SUBJECT: NFPA 1971 Proposed TIA No. 1594 **Circulation of TC Ballots**

NFPA 1971-2018 Edition

TIA Log No.: 1594

Reference: 7.1.23, 8.62, Table A.4.3.4(a), Table A.4.3.4(f) and Table B.2

Test Method	Test Method Description	Test Method Application
	Exterior of Xenon Apparatus.	
	Interior of Xenon Apparatus in Use.

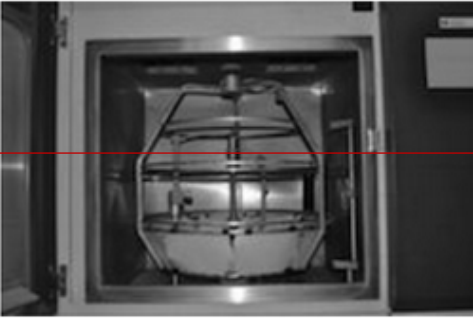
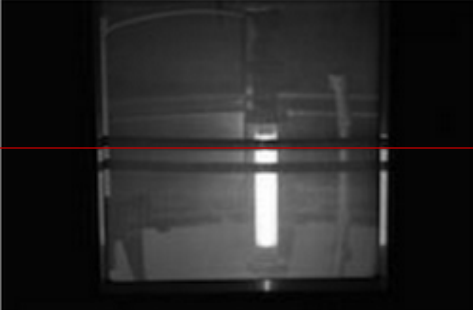
5. Delete the line entry 7.1.23, and photos for “Exterior of Xenon Apparatus” and “Interior of Xenon Apparatus in Use”, and update the cross references in Table B.2 Garments as shown here:
